BEFORE AN INDEPENDENT HEARING PANEL

Of applications to Hawke's Bay
Regional Council for resource
consents to take and use Tranche
2 groundwater

**EVIDENCE OF NEIL THOMAS
ON BEHALF OF HAWKE'S BAY REGIONAL COUNCIL**

GROUNDWATER

Figure 1: Groundwater levels in bore 1426 compared to annual water use across the Ruataniwha Basin

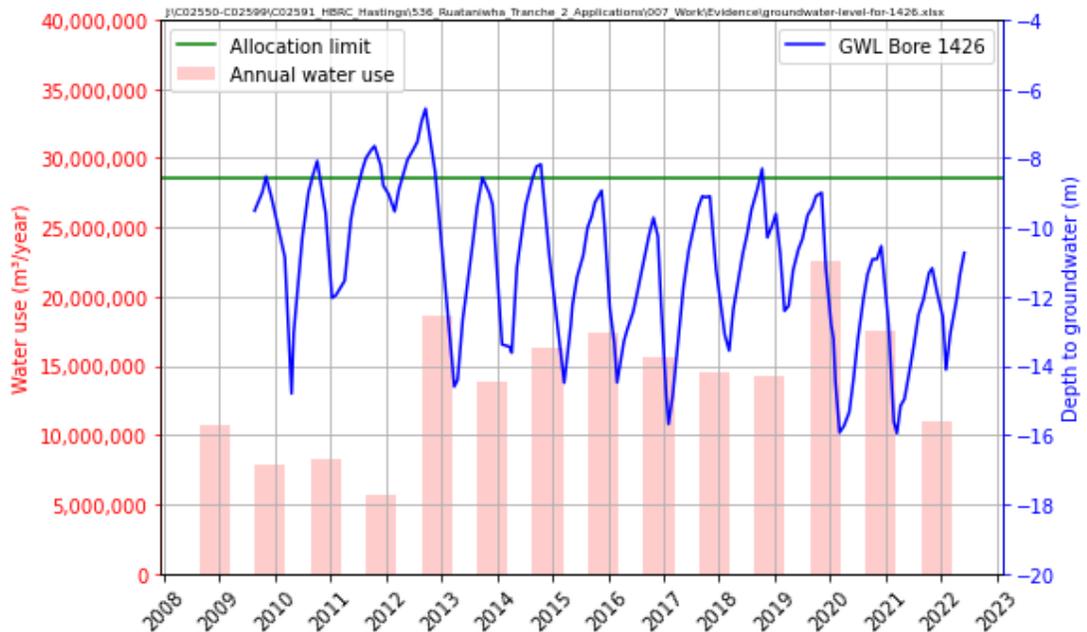
- 4.7** Figure 1 also shows a plot of groundwater levels in bore 1426 (screened from 38 m below ground level (bgl) to 44 m bgl and located around 2.5 km west of Ongaonga). Groundwater levels in bore 1426 appear to generally follow the pattern of groundwater abstraction, with lower levels occurring following periods of increased groundwater abstraction, such as 2019/2020. The total decline in winter recovery groundwater levels in bore 1426 since 2008 appears to be around 2 m. It is not possible to comment on the pattern of summer declines in bore 1426 because it is used for irrigation. I note that the effects on this bore have been modelled in the Aqualinc report (Weir, 2022), as shown in Figure 28 of that report, which indicates, as expected, a decrease in both winter and summer levels.

- 4.8** The current level of available groundwater allocation for the Ruataniwha Basin (the Tranche 1 allocation) is also shown in Figure 1. Between 2008 and 2022, the full allocation of groundwater has not been used and therefore the current pattern of decline could continue or increase in bores across the basin. As I will describe further in my evidence, an increase over time in Tranche 1 abstractions has not been provided for in the assessment of effects. The proposed Tranche 2 groundwater takes would also increase groundwater use within the basin and therefore I would expect the current pattern of groundwater level declines to continue or increase.

Figure 2: Location of Applicants' properties compared to the location of nearby pumping tests.

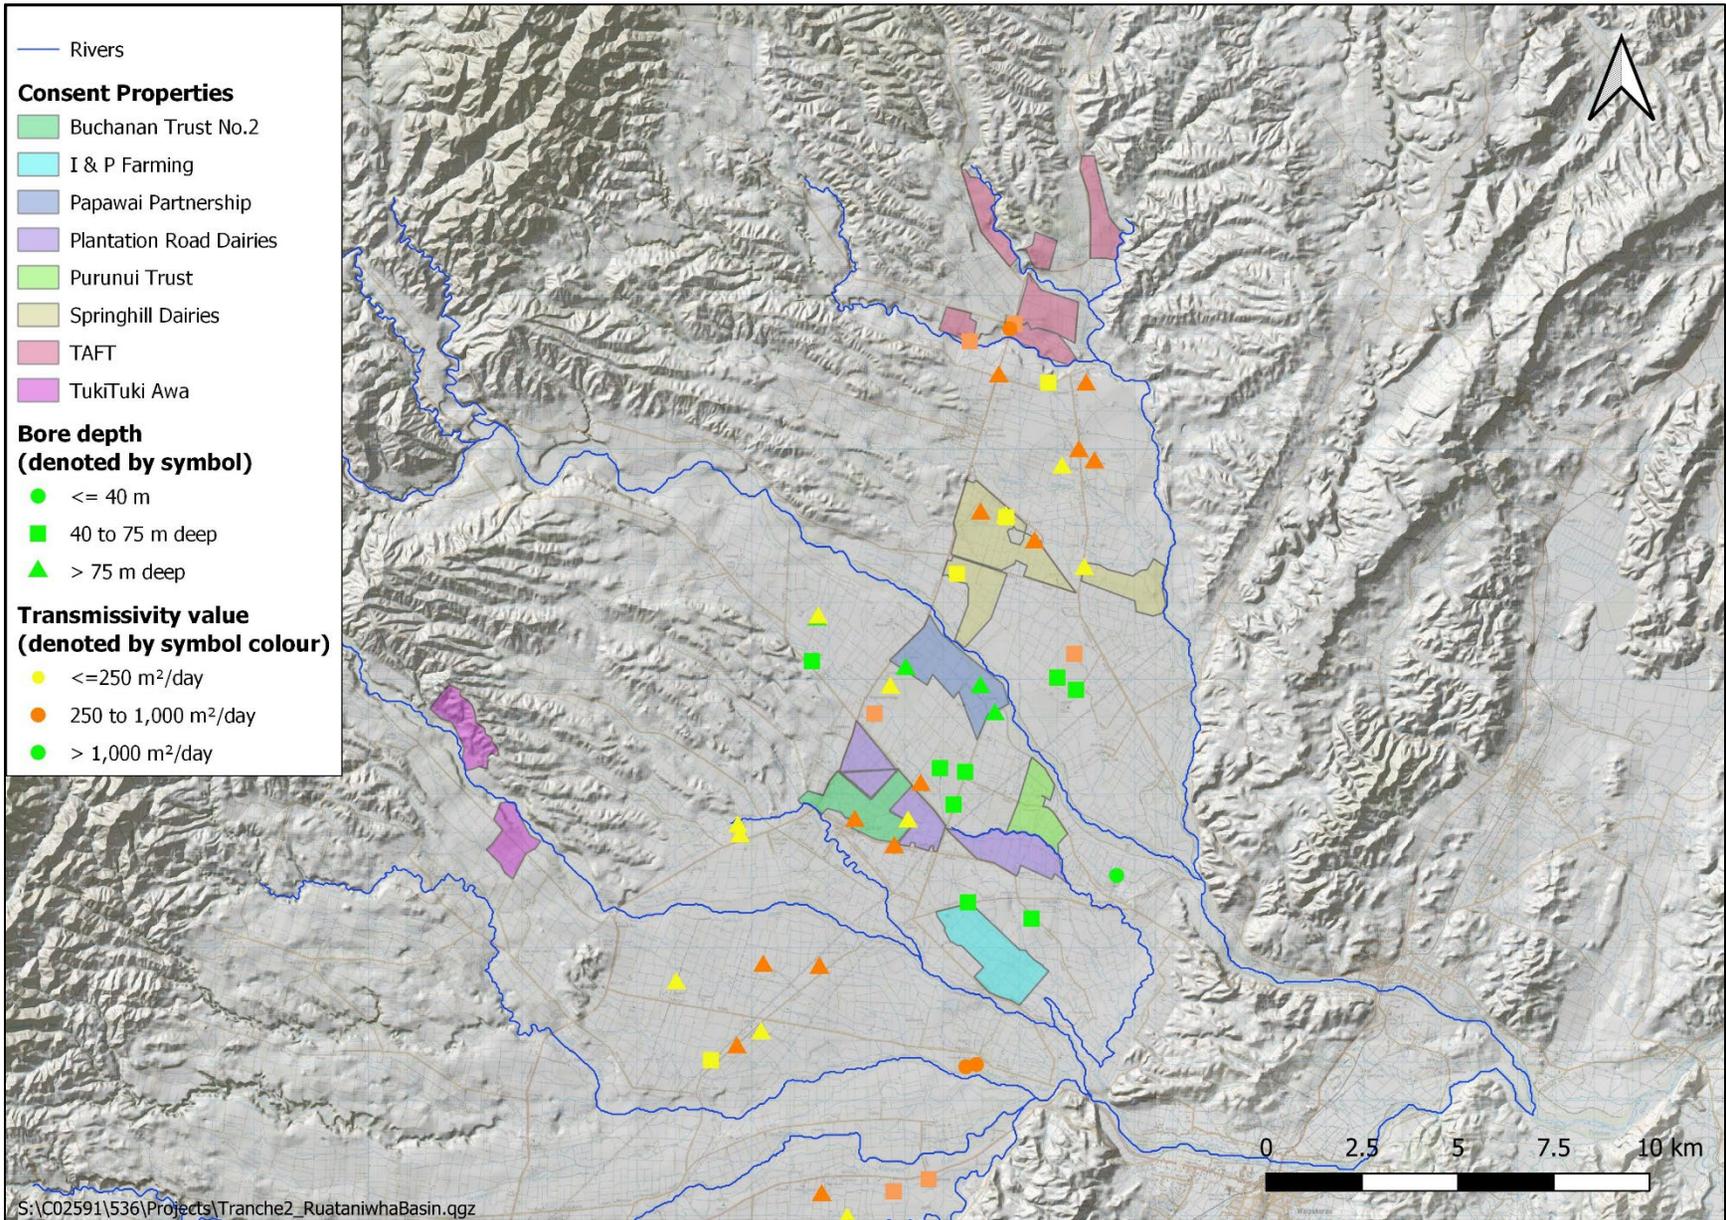
7.6 The calibration of the model is unusual. Whilst I appreciate the reasons that the method was adopted, in my opinion this has led to relatively large uncertainty in the model predictions because the inputs to the model are not well constrained by the calibration exercise i.e. the values of aquifer parameters used to calibrate the model fall into a reasonably wide range; therefore any predictions from the model, such as the impacts of groundwater abstraction on small streams and rivers within the basin, could also fall in a wide range.

7.7 I note that some data from pumping tests has been used in the model construction which may help to constrain the modelled aquifer parameters and a map showing the location of pumping test data compared to the location of the Applicant's properties is provided in Figure 2. In some areas, for example the Papawai Partnership property, there appear to be several aquifer tests available, which help to constrain the model to observed data in that area, but in other areas, such as around the I & P Farming property and the Purunui Trust property, there is less nearby data. However, it should be noted that the results from the pumping tests typically represent a relatively small area around the bore, both vertically and horizontally. In the model, these results have been applied to the whole thickness of the strata at that location, which will vary in reality, leading to uncertainty in effects. For example localised effects such as well interference will vary depending on the aquifer properties at the depth of the Tranche 2 bores and the existing bores. I have the following key concerns with the model calibration:

Figure 3: Comparison of modelled and observed flow duration curves for the Tukituki River at Tapairu Road. Flow rates are shown in m³/s.

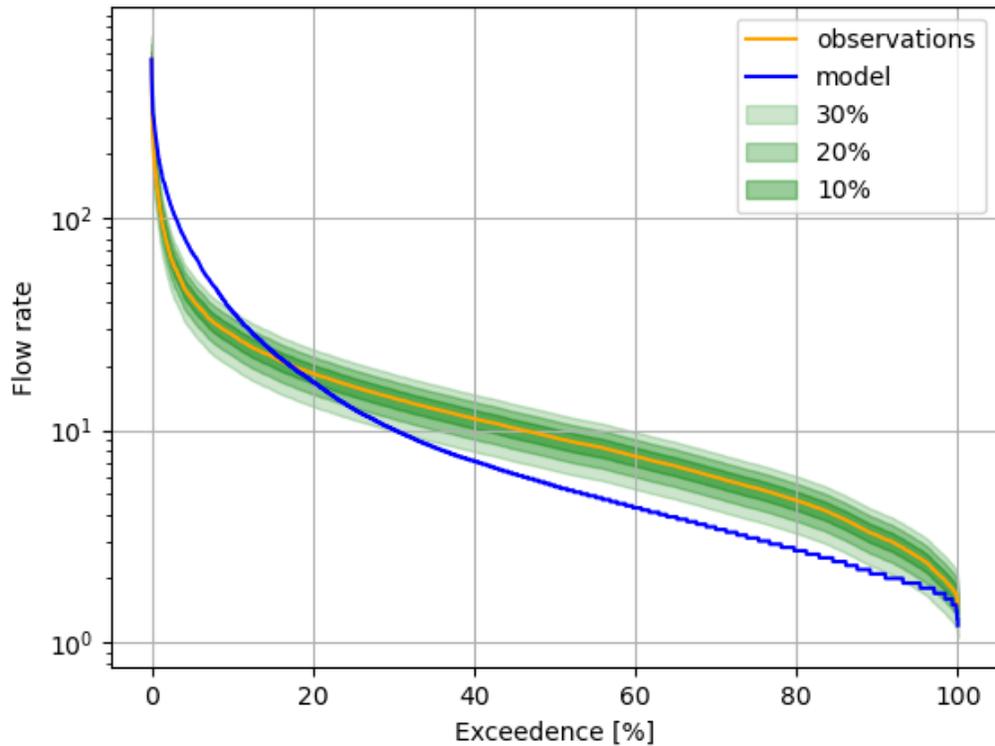
- (k) In Figure 3 of my evidence I have shown a plot of the modelled and observed flows at the Tukituki River Tapairu Road monitoring site (i.e. at the basin outlet). This plot was generated by the HBRC surface water science team. The flows are shown as a flow duration curve, i.e. the percentage of time that a flow is exceeded across a flow record. These plots are a standard means of assessing whether a model represents an observed flow record. As Figure 3 shows, the match is not particularly good, particularly between the 20th and 90th flow percentiles, even allowing for up to 30% errors in the observed flows. I have shown this plot to highlight that the statistics as presented by the Applicants do not always show the whole picture of model to observed misfits.

- (a) Estimate changes in the low flow regime at the surface water calibration points at the basin outlets, because the model appears to reasonably simulate low flows at those locations (noting Figure 2, above).

Figure 4: Location of monitoring bores between 0 and 10 m deep.

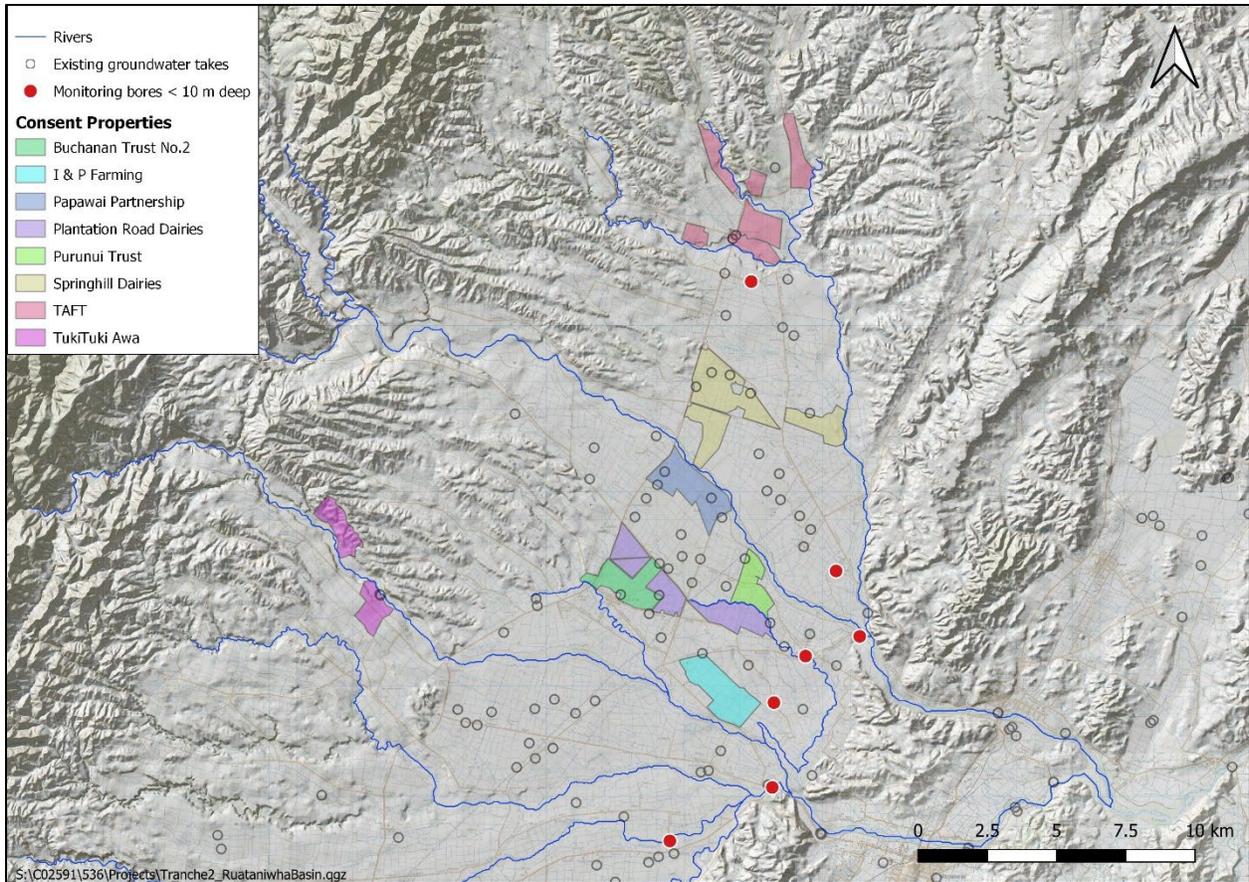
- 9.12** To determine the seasonal water level change and cumulative effect at different depths across the basin, the Applicant has used HBRC monitoring bores of different depths across the basin. For example, they have used six bores in the 0 to 9 m depth range to extrapolate seasonal variations and cumulative effects across the basin. A map showing the locations of the six bores is shown in Figure 4.

9.13 As is readily apparent from Figure 4, extrapolating the observed seasonal changes in the monitoring bores between 0 and 10 m deep to other shallow bores across the basin is not appropriate because of the large intervening distances and will lead to incorrect estimates of the seasonal and cumulative changes in other shallow bores located away from the observation bores.

Figure 5: Location of monitoring bores >50 m deep.

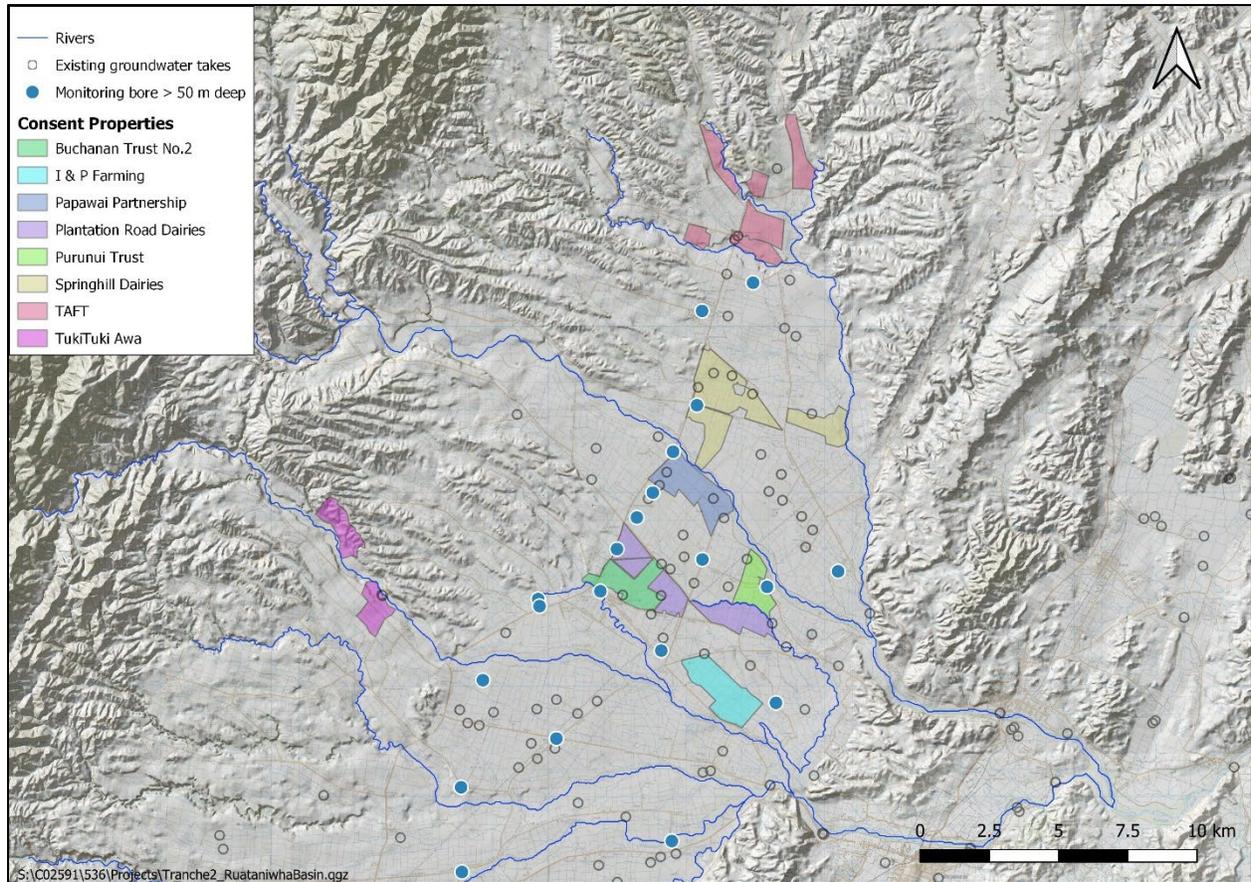
9.14 Similar issues are present with bores assigned to other depth intervals although I note that there are generally more observation bores that represent strata that is more than 50 m deep (Figure 5). However, there are concentrations of abstractions where no deeper monitoring bores are present (for example north of the Waipawa River) and where the seasonal and cumulative drawdown effects are not likely to be correctly estimated using the Applicants approach.
